PUBLIC INTEREST REVIEW FOR GROUNDWATER APPLICATIONS

TO: Water Rights Section Date 03/09/2023
 FROM: Groundwater Section Phillip I. Marcy
 Reviewer's Name
 SUBJECT: Application G- 18894 Supersedes review of 02/14/2020
 Date of Review(s)

A. GENERAL INFORMATION: Applicant's Name: Gregory L. Bingaman County: Union

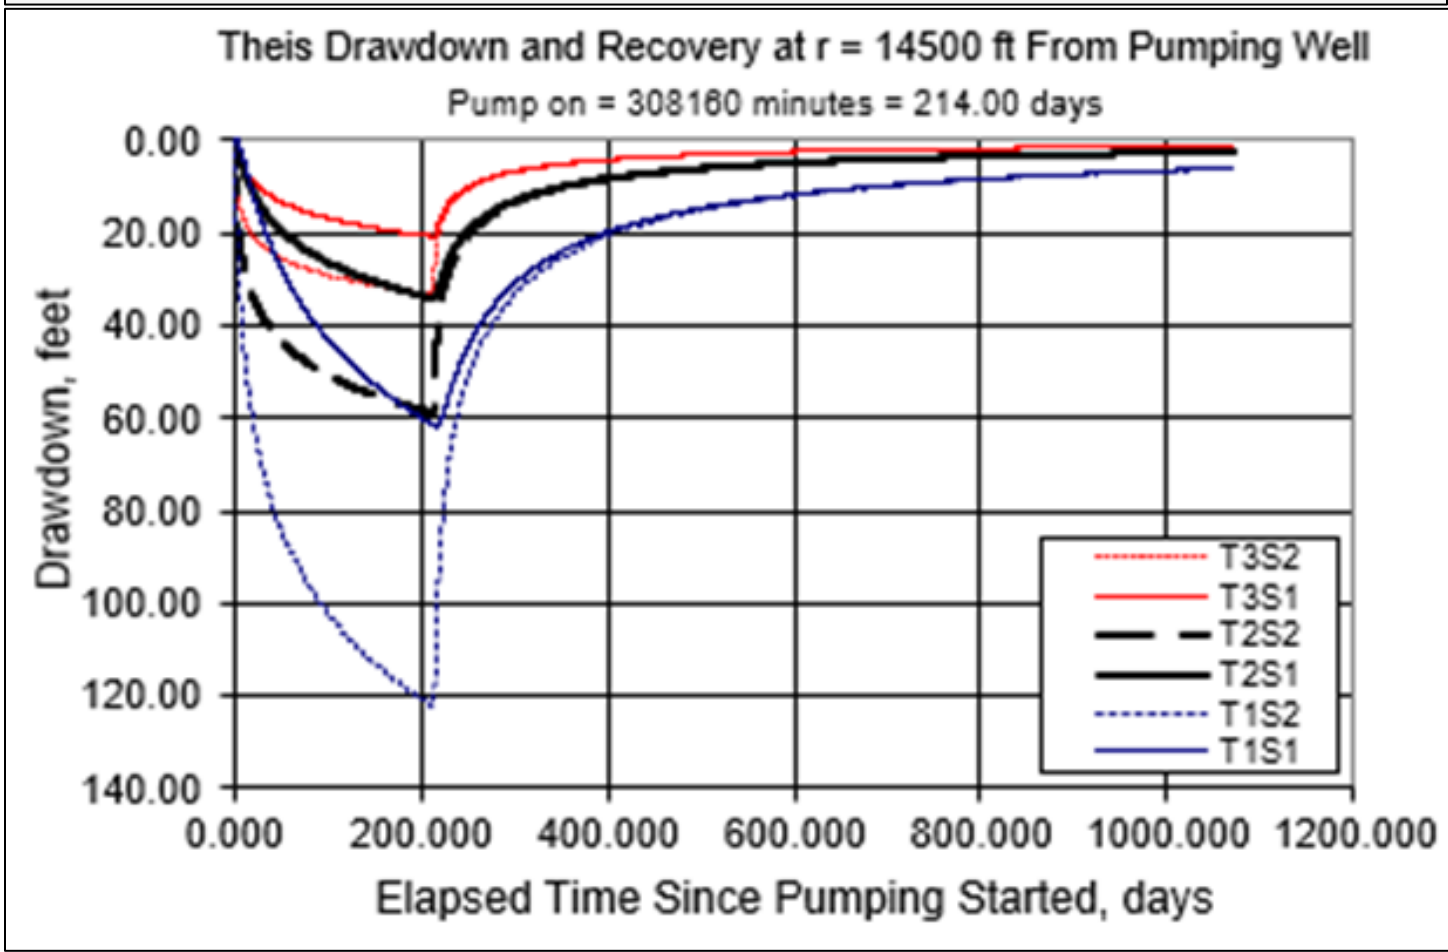
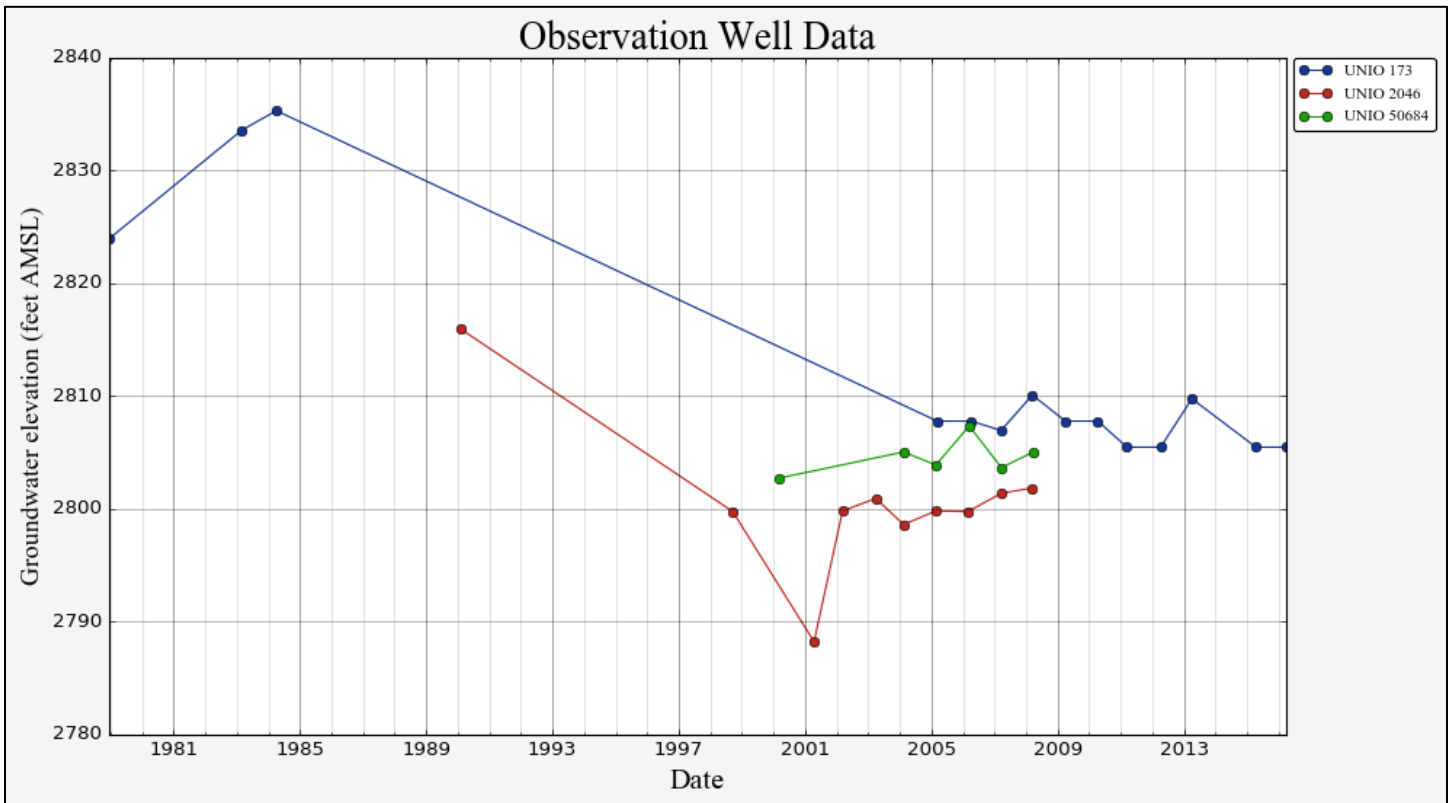
Expected drawdown (using T2 curves) at UNIO 173 is between roughly 34 and 59 feet after pumping UNIO 50684 for 214 days at a rate of 15.73 cfs, the combined rate of current authorizations and the proposed rate on this application and G-18895.
